**FLATHEAD COUNTY PLANNING AND ZONING OFFICE**  
**CONDITIONAL USE PERMIT REPORT FCU-10-06**  
**JUNE 22, 2010**

A report to the Flathead County Board of Adjustment, regarding a request by Gary Krueger for a conditional use permit to allow for Gravel Extraction allowing batching facilities in the West Valley Zoning District.

Figure 4: The approximate location of the proposed batch plants.

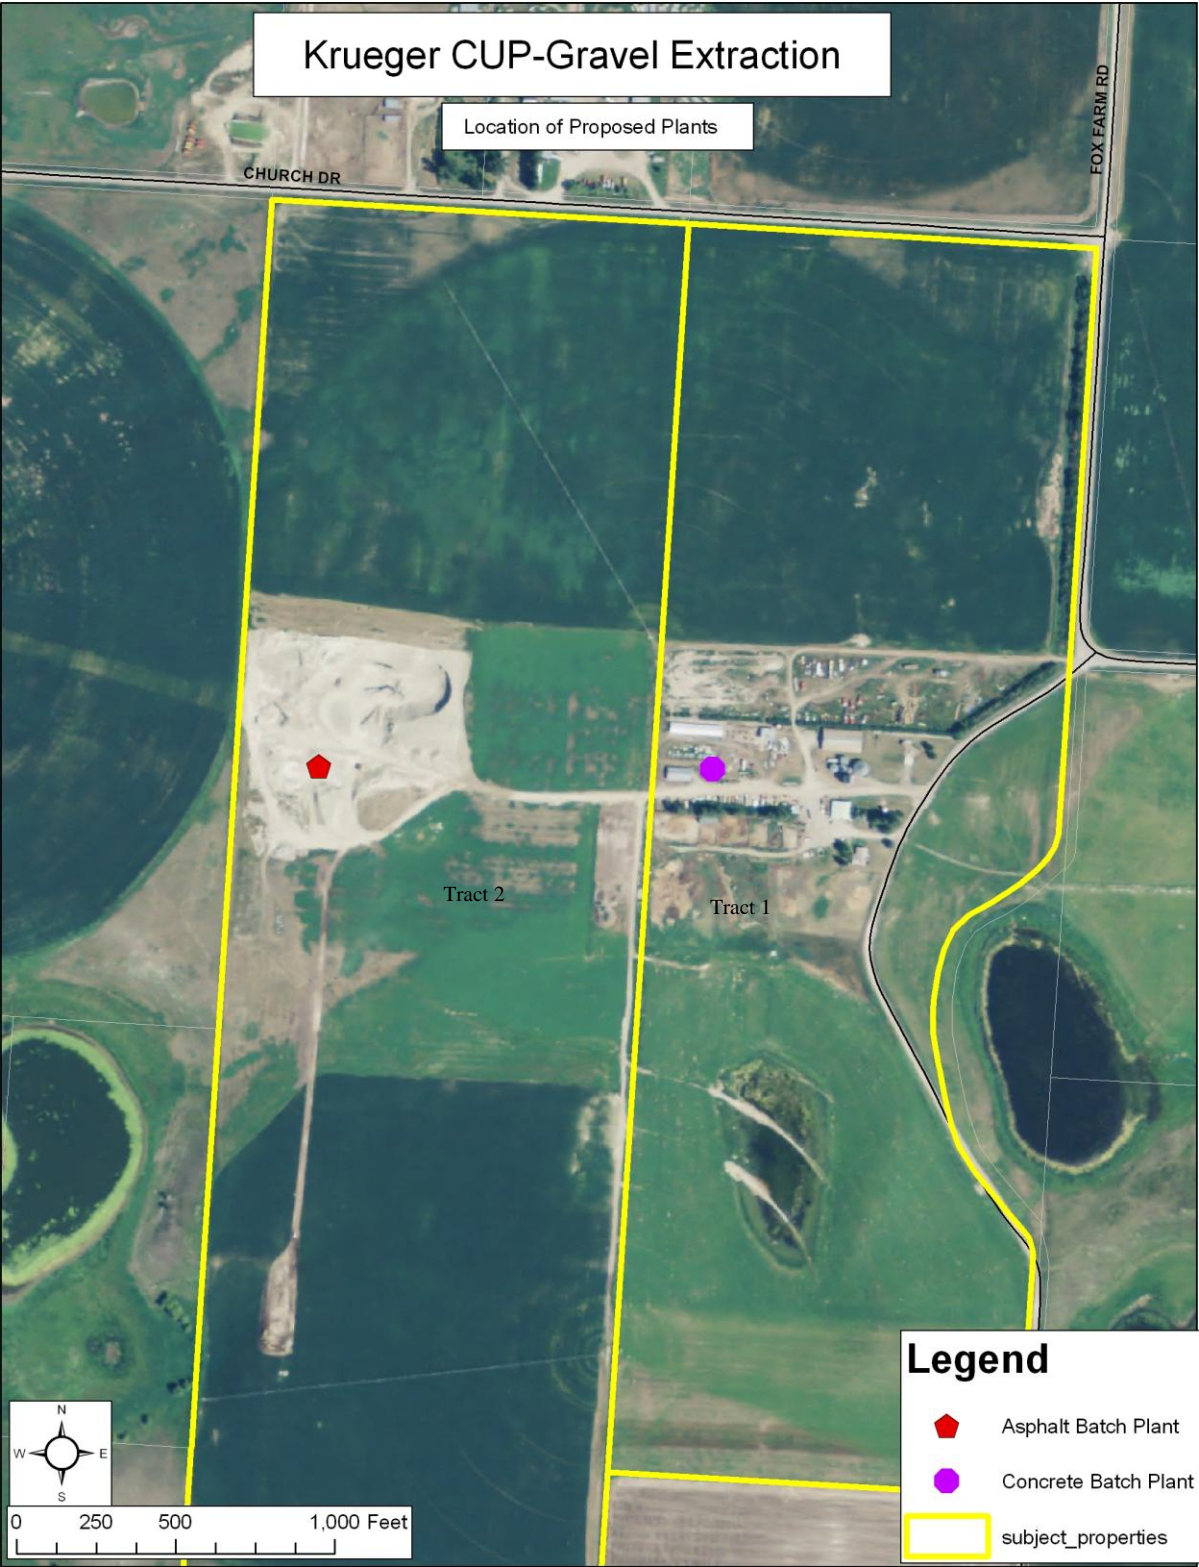
The applicant is proposing to install two types of batch plants on two tracts of land (figure 4). A concrete batch plant is proposed to be installed on Tract 1. Concrete batch plants combine, distribute and weigh gravel, sand, water, and chemical mixtures such as lye into a mixing truck. The mixing truck then transports the cement to construction sites. A temporary asphalt batch plant is proposed on Tract 2. Asphalt batch plants require mixed aggregates, sand and filler be heated and then mixed with a petroleum based product resembling tar. The heated mixture is then distributed into trucks and then hauled to construction sites.

The concrete batch is proposed to be placed approximately 500 feet off of West Springcreek Drive on the pit road within the developed farmstead area. The concrete batch plant will be constructed as a permanent structure. The asphalt batch plant will be constructed within the staging area at the bottom of the existing permitted gravel pit. The asphalt batch plant will be a temporary plant.

2. The concrete batch plant shall be located on the western edge of tract 1 as indicated in figure 4 of this report.
3. The applicant shall contact the Flathead County Road and Bridge Department in order to obtain an approach permit for the use onto West Springcreek road if one has not been obtained. If the applicant has an approved approach, the applicant shall contact Flathead County Road and Bridge Department in order to determine if the current access can accommodate the proposed use. The applicant shall have the determination and/or the approach permit from the Flathead County Road and Bridge Department available to the Flathead County Planning and Zoning Office upon request.

**Figure 5: Varying distances from the proposed asphalt batch plant.**

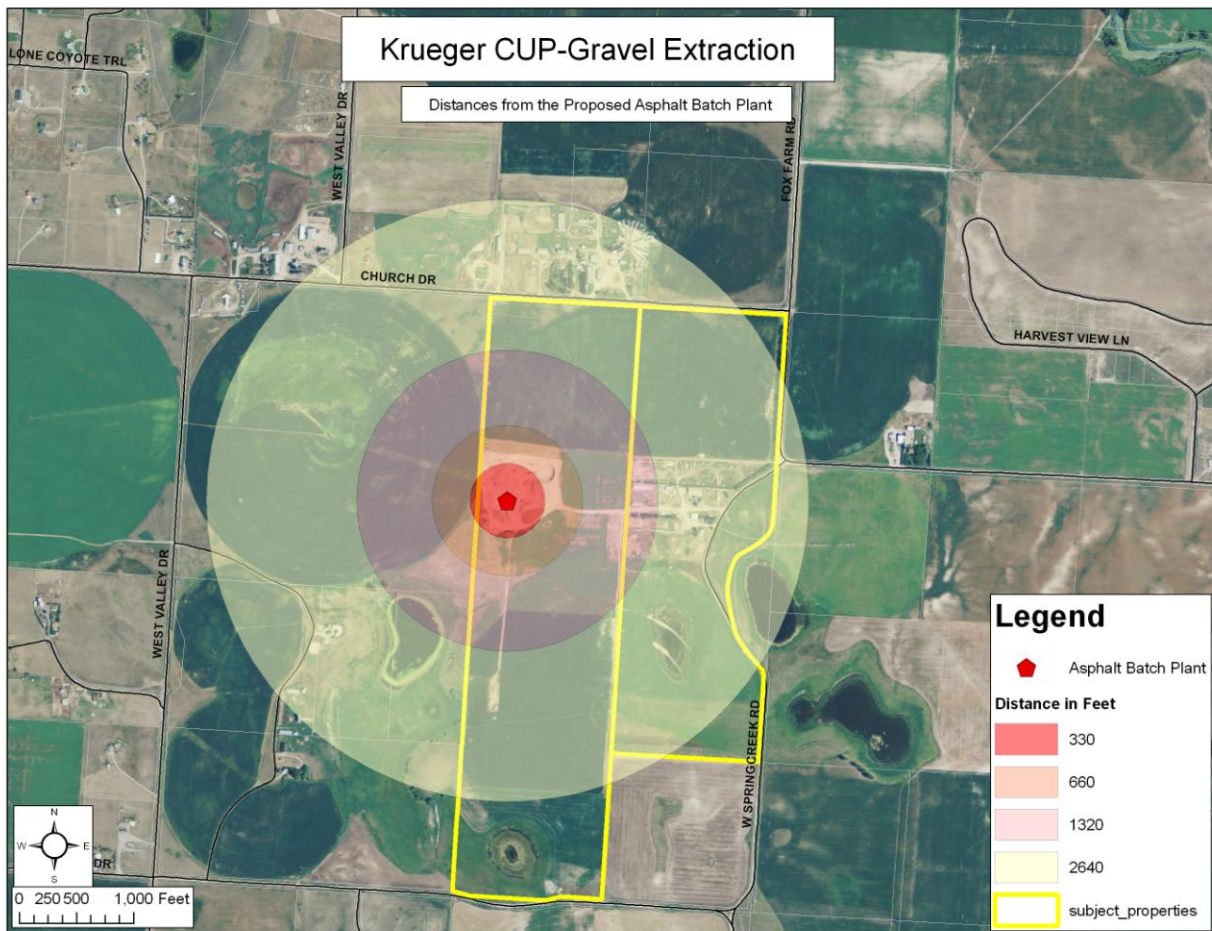
Staff conducted an analysis of the distances from the proposed asphalt batch plant site and adjacent residences using ArgGIS software and 2009 aerial photography (figure 5). Distances selected by staff were 330 feet (1/16<sup>th</sup> of a mile), 660 feet (1/8<sup>th</sup> of a mile), 1,320 feet (1/4 of a mile), and 2,640 feet (half a mile). Within

2,640 feet, there are three residences when including the farm house on the subject property, and no residences within 1,320 feet.

**Figure 6: Varying distances from the proposed concrete batch plant.**

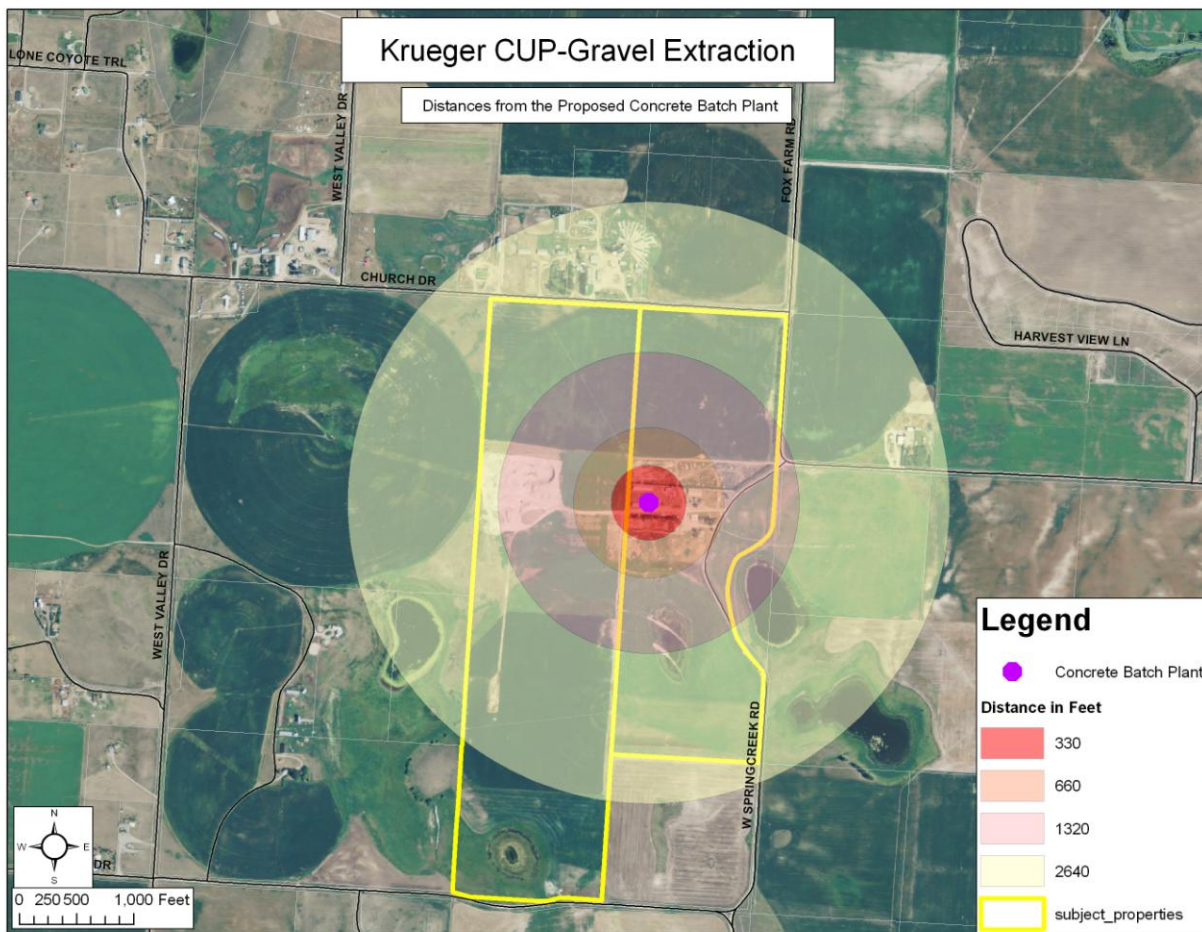
The same analysis was done for the concrete batch plant (figure 6). There are 3 residences within 2,640 feet from the subject property and only one, a house used for employees of the applicant, within 1,320 feet. The residence owned by the applicant and used as an employee house is less than 660 feet from the proposed site of the concrete batch plant, and on the same tract of record.
